# **Invitation for Bid No. 2022-042**

# Union County Government Center Generator Replacement

## **ADDENDUM No. 2**

ISSUE DATE: August 25, 2022

ELECTRICAL
POWER PLAN

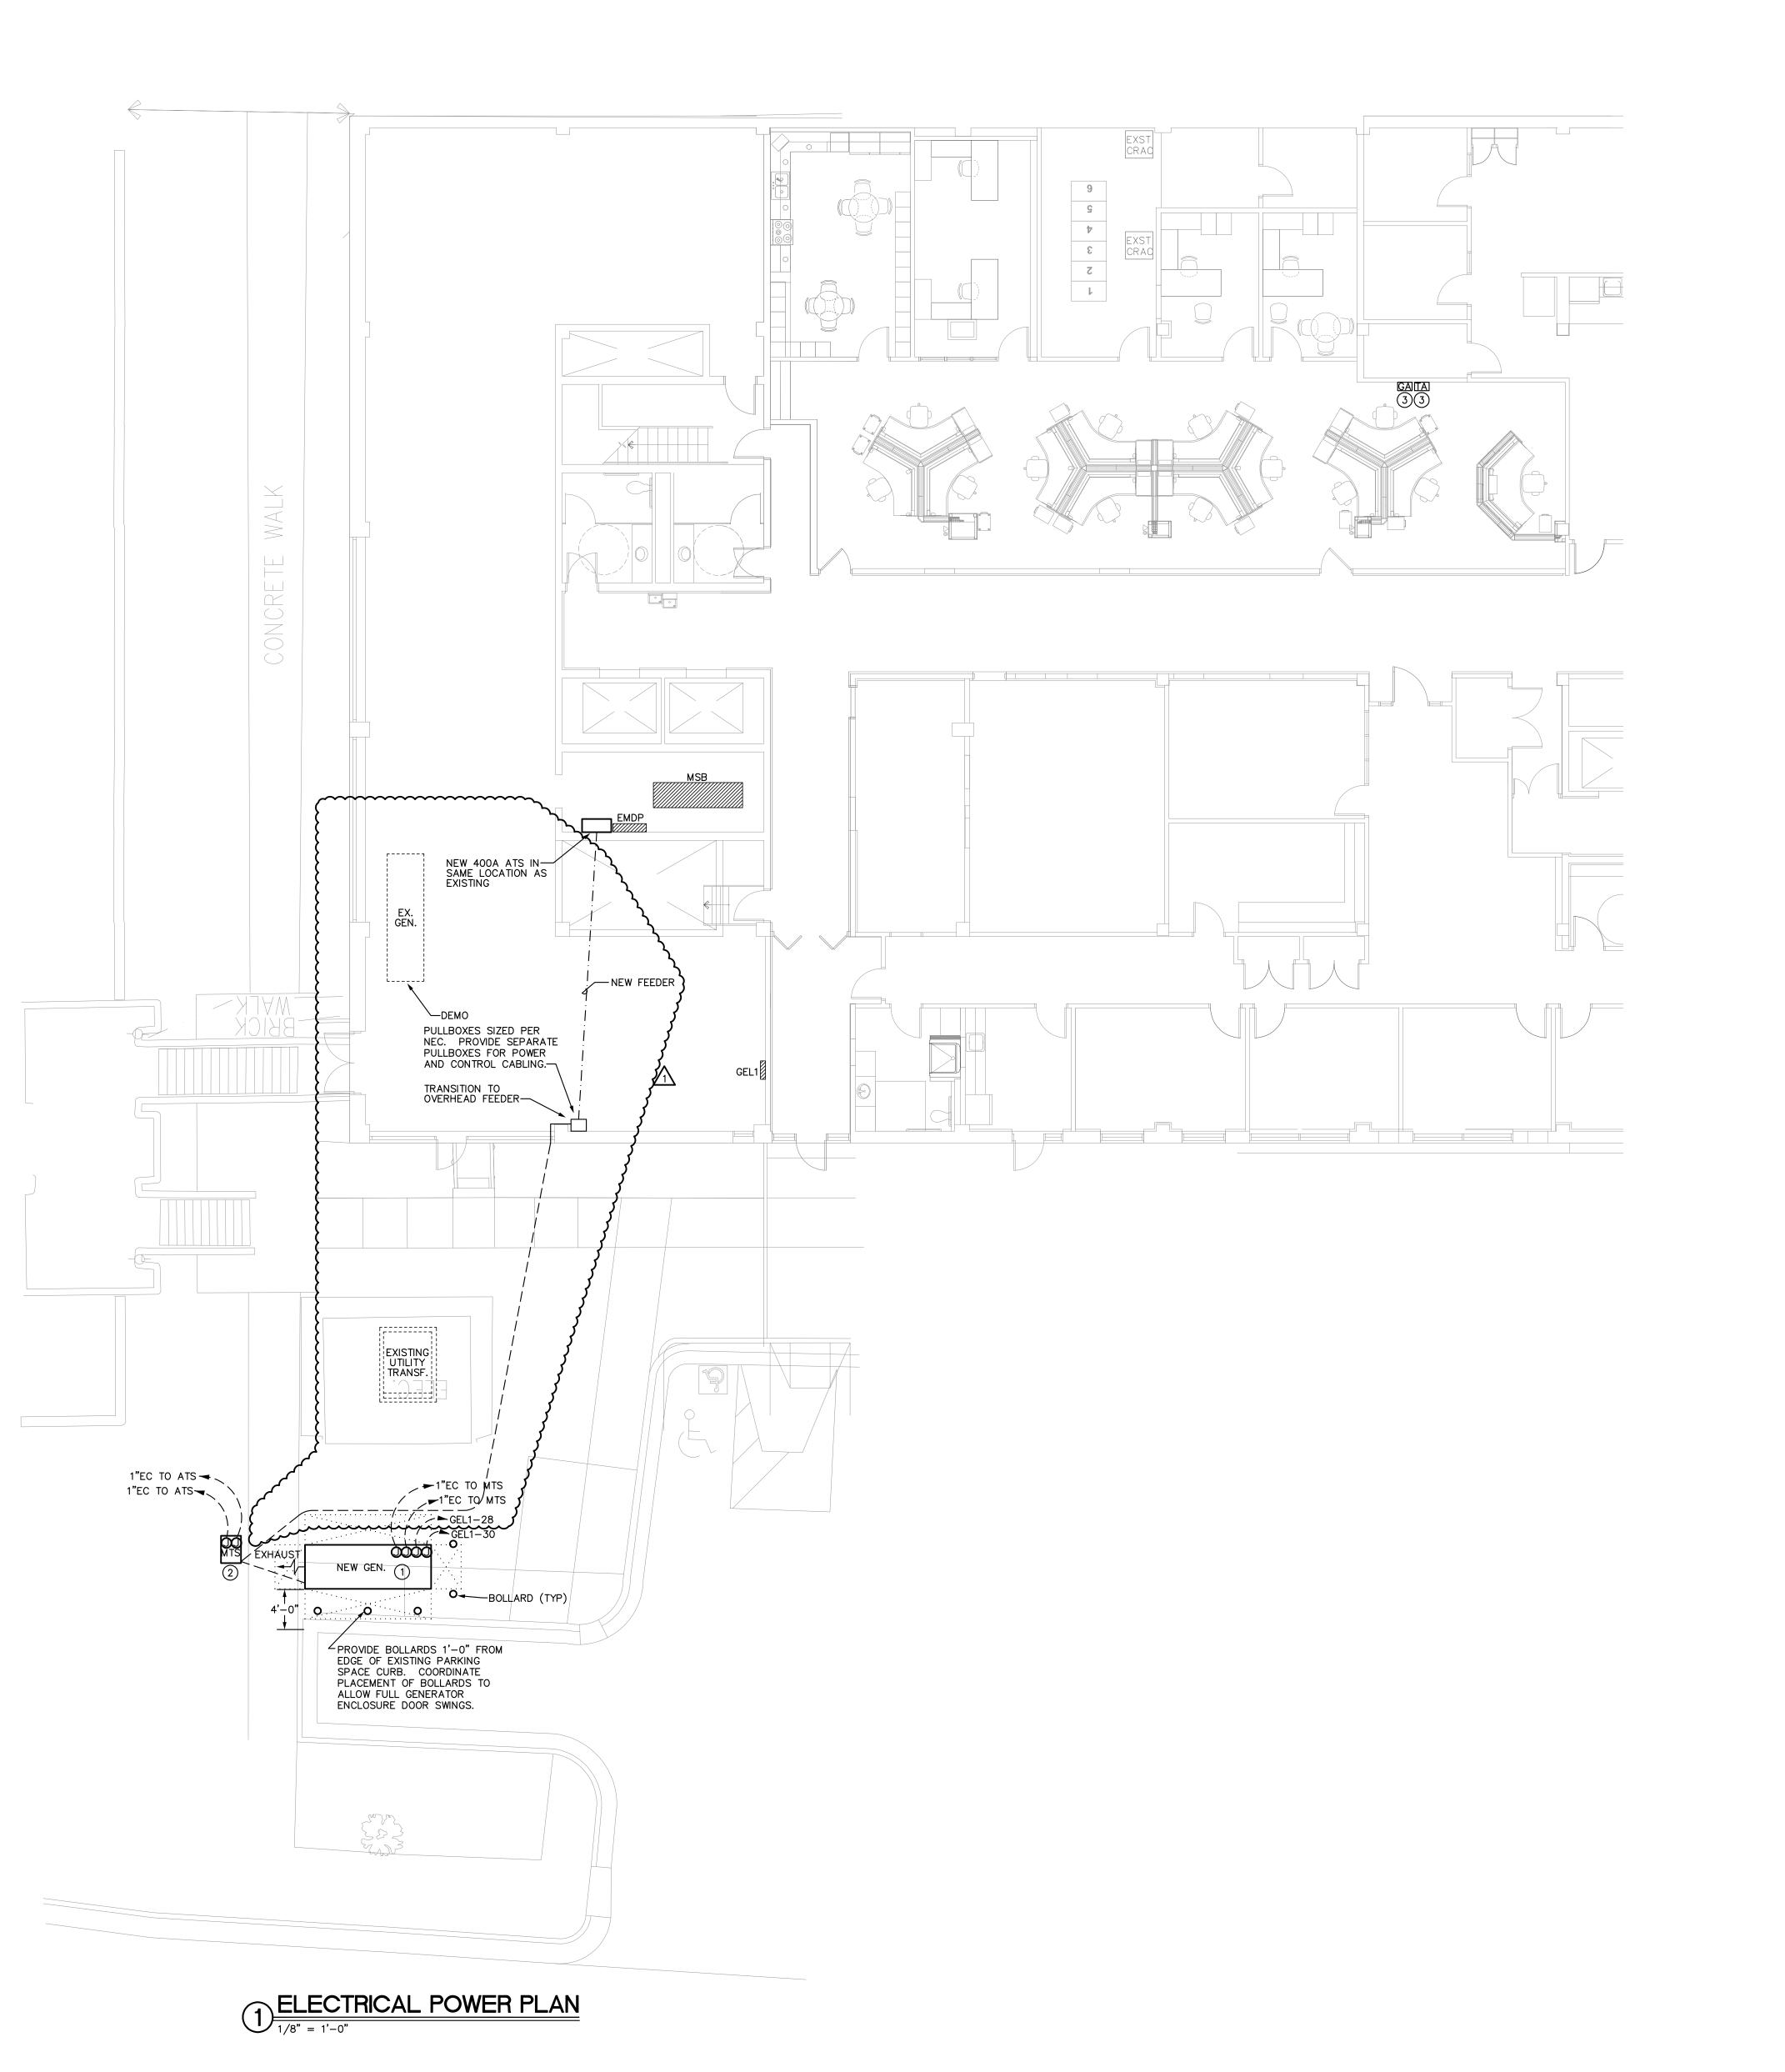
Revise proposed feeder and circuit routings from exterior MTS to interior ATS as indicted below. Coordinate with gas piping routing.
